City of Detroit
Inter-Departmental Communication

RE: Petition No. 1129
Request for Conversion to Easement of the North/South Alley in the Area Bound
by Faust, Fitzpatrick, Plymouth and Chesapeake Railroad

NOTICE OF PROPOSED CHANGE IN PROPERTY

REQUEST TO CONVERT TO EASEMENT
 BRACE AVE. 60 FT. WD. AND THE
 NORTH/SOUTH PUBLIC ALLEY, 20 FT. WD.
 IN THE AREA BOUND BY
 FAUST, FITZPATRICK, PLYMOUTH AVE.
 AND CHESAPEAKE & R.R.

CITY OF DETROIT CITY ENGINEERING DEPARTMENT SURVEY BUREAU	
JOB NO.	01-01
DRWG. NO.	X 1129

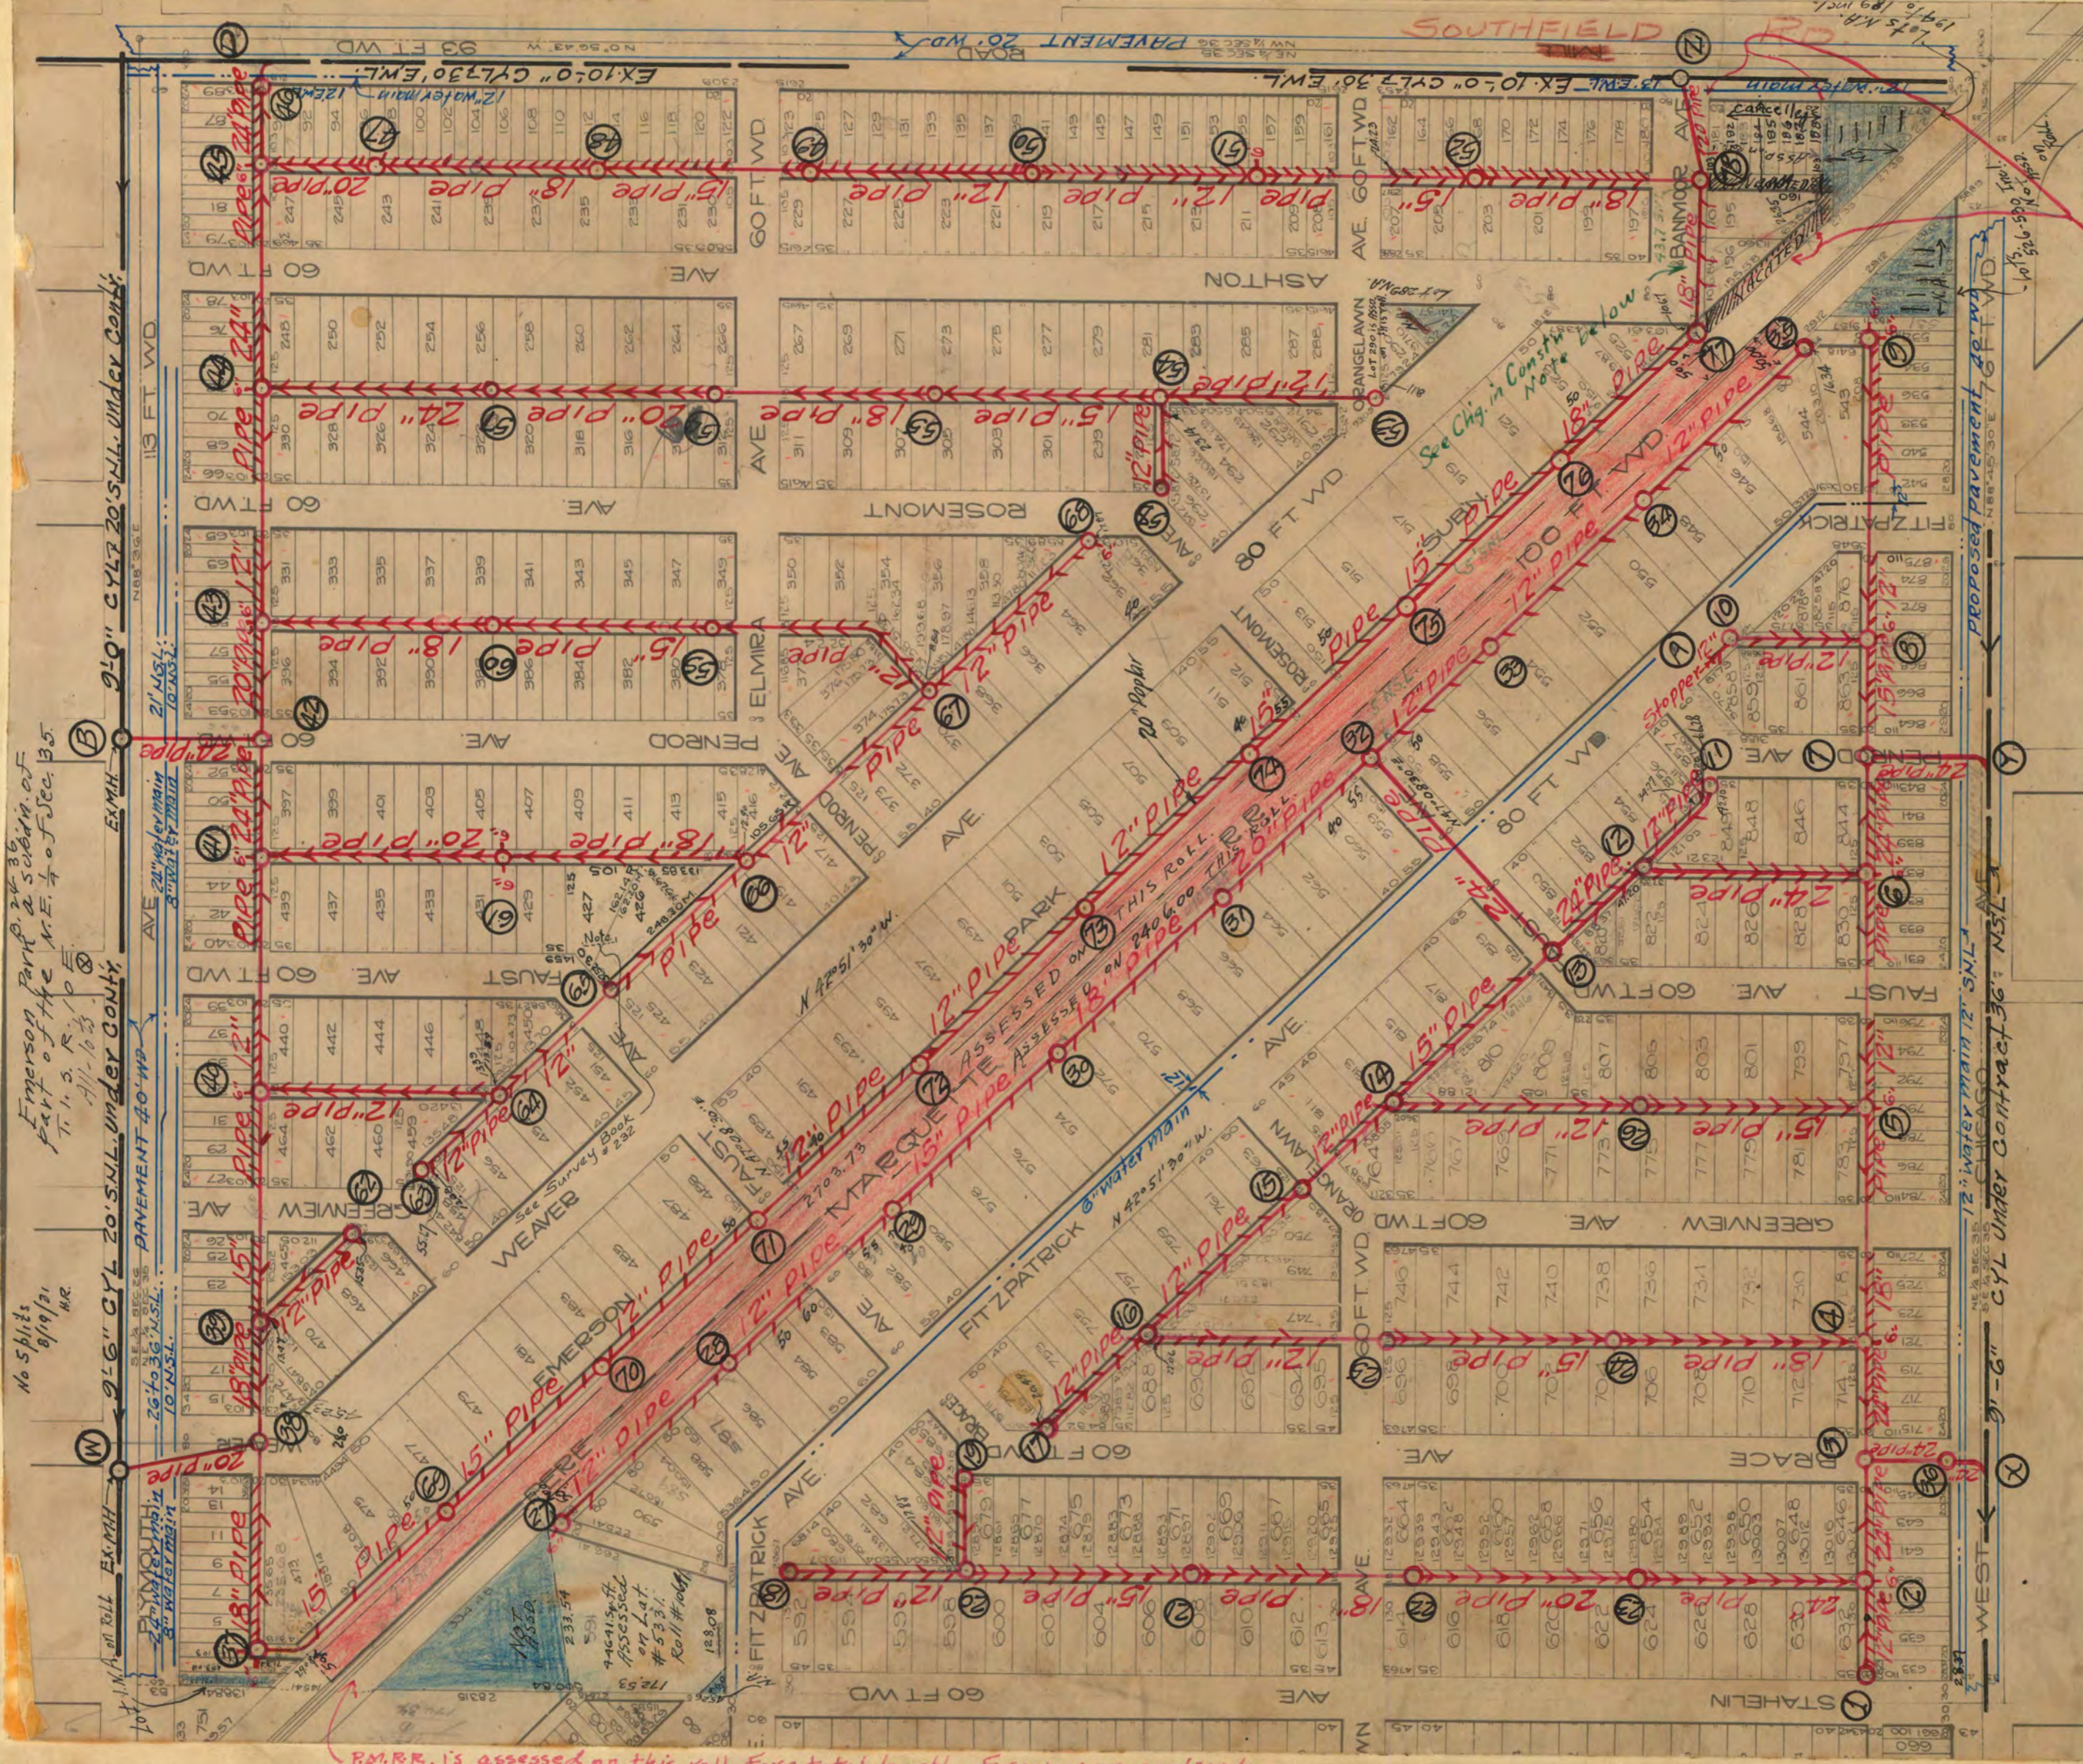
- Our records indicate that there is a sewer in the area of conversion to easement. DWSD has no objection to the requested conversion to easement provided that the attached Provisions for Conversion to Easement are strictly followed.
